## PSP 1078 & 1080

# Plumpton PSP & Kororoit PSP

APPENDICES
Closing Submission - C146 & C147
Amendment to the Melton
Planning Scheme

Re: Melbourne Water response to Urban Floodway Zone – Kororoit and Plumpton PSPs

Figure 1 - Location of current Urban Floodway Zone (UFZ) on Property 31 and 32 of the Plumpton PSP. The pre-development flood extent is shaded blue-grey and the post-development waterway corridor is shaded green. The base map is Plan 4 'Land Use Budget' of the Plumpton PSP.

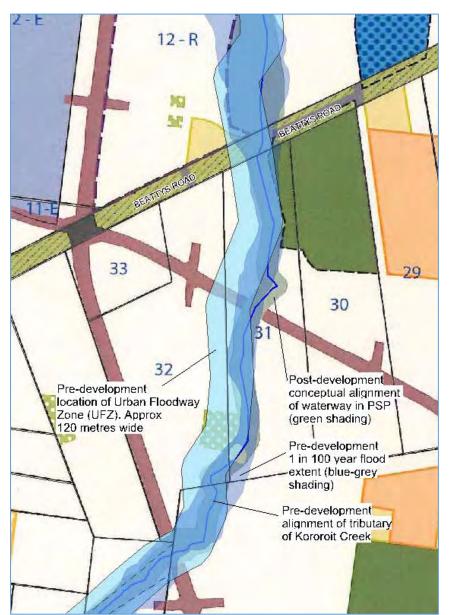
The properties at 365 & 391 Beattys Road, Plumpton are (currently) partially zoned Urban Floodway Zone (UFZ) in the Melton Planning Scheme. The current UFZ is approximately 120m wide (see Figure 1). In designing the Olive Grove Development Services Scheme (DSS4142), Melbourne Water has determined a waterway corridor width of approximately 60m is required to contain 1 in 100 year flows (hydraulic width) with a buffer for riparian vegetation and maintenance access (refer to Waterway Corridors in Greenfield Developments for more information on determining waterway corridor widths).

The current size and location of the Urban Floodway Zone (UFZ) does not match the location of the conceptual waterway corridor in the exhibited Plumpton PSP (see Figure 1). It is clear from Figure 1 that the waterway corridor is located to the eastern side of the current alignment of the UFZ.

Therefore, the current Urban Floodway Zone (UFZ) will not reflect the current 1 in 100 year flood extent as the catchment develops and stormwater management assets such as retarding basins and wetlands are constructed in the catchment (see Plan 10 – Integrated Water Management Plan Plumpton PSP for location of assets).

Retention of the the existing UFZ alignment would be unnecessary because the majority of the area would not be subject to flooding once stormwater assets are constructed in accordance with the DSS. Melbourne Water would have no objection to a Land Subject to Inundation Overlay (LSIO) over

the exhibited waterway corridor in the Plumpton PSP to ensure there is a planning scheme mechanism which identifies flood-prone land post-development of the PSP. There are some potential drawbacks to this option which are discussed in the section 'Implementation of the Precinct Structure Plan' below. Melbourne Water would not support an Urban Floodway Zone (UFZ) over the conceptual waterway corridor at this time because the location of the waterway may be subject to change based on detailed design. The UGZ provides flexibility to change the alignment of the waterway at detailed design without requiring a planning scheme amendment to allow other use and development within the potentially redundant UFZ.

Figure 2 - Location of current Urban Floodway Zone (UFZ) on Property 67 & 68 of the Kororoit PSP. The pre-development flood extent is shaded blue-grey and the post-development waterway corridor alignment is shaded green.

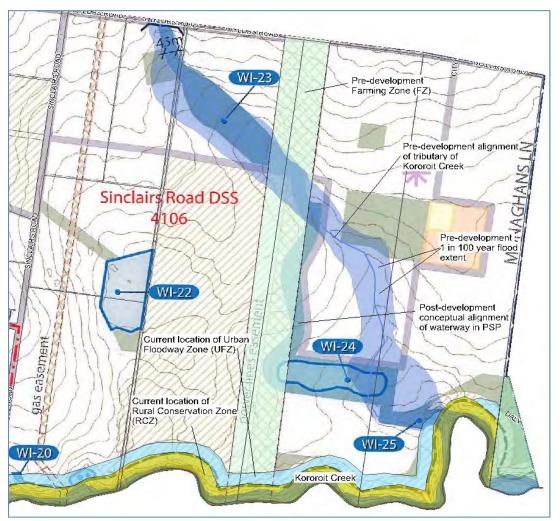
The Urban Floodway Zone (UFZ) is currently located along the southern boundary of properties parallel with Kororoit Creek (Figure 2). It is important to note that large parts of the Urban Floodway Zone (UFZ) on these properties are not currently subject to flooding from Kororoit Creek in a 1 in 100 year flood event.

The pre-development 1 in 100 year flood extent is shown in Figure 2 below. Figure 2 clearly shows the waterway location would change under developed conditions after extensive discussions with the landowner. The waterway would be constructed west (Property 68) of the current alignment as agreed in-principle in Melbourne Water's letter to Mr Jeff Garvey of 23 November, 2016.

Melbourne Water does not seek retention of the UFZ in the current (pre-development) location because the area is not subject to flooding in a 1 in 100 year flood event and will not be under developed conditions. It is essential that an appropriate waterway corridor is provided for Kororoit Creek; however this has been achieved through the conservation area of the Kororoit PSP (see Plan 3- Future Urban Structure).

If the current (pre-development) 1 in 100 year flood extent on these two properties were covered by an LSIO it would generate numerous unnecessary development referrals to Melbourne Water (at the time of subdivision) as the waterway would be constructed further west. This is discussed further using an example in 'Clyde Creek PSP Implementation' below.

Melbourne Water would have no objection to a Land Subject to Inundation Overlay (LSIO) over the conceptual alignment of the waterway corridor in the Kororoit PSP (refer to Figure 2). An LSIO may increase unnecessary referrals at the time of PSP implementation if the waterway corridor or WI-24 require changes at detailed design but it would clearly show areas subject to flooding after implementation of the PSP.

Figure 4 - Location of Land Subject to Inundation Overlay in the area adjacent to Tuckers Road and Pattersons Road, Clyde North. The location of lots and roads is shown in the black outline.

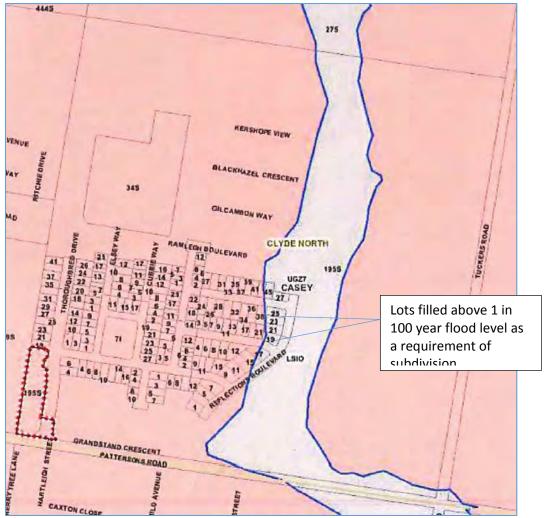
As the area has developed, there have been a number of requests to amend the Casey Planning Scheme between Tuckers Road and Pattersons Road to remove the LSIO. The area is no longer subject to flooding and there have been unnecessary development referrals to Melbourne Water (as the regional floodplain management authority) because stormwater assets have been constructed in accordance with the PSP and lots have been filled (see Figure 4, 15-27 Reflection Boulevard).
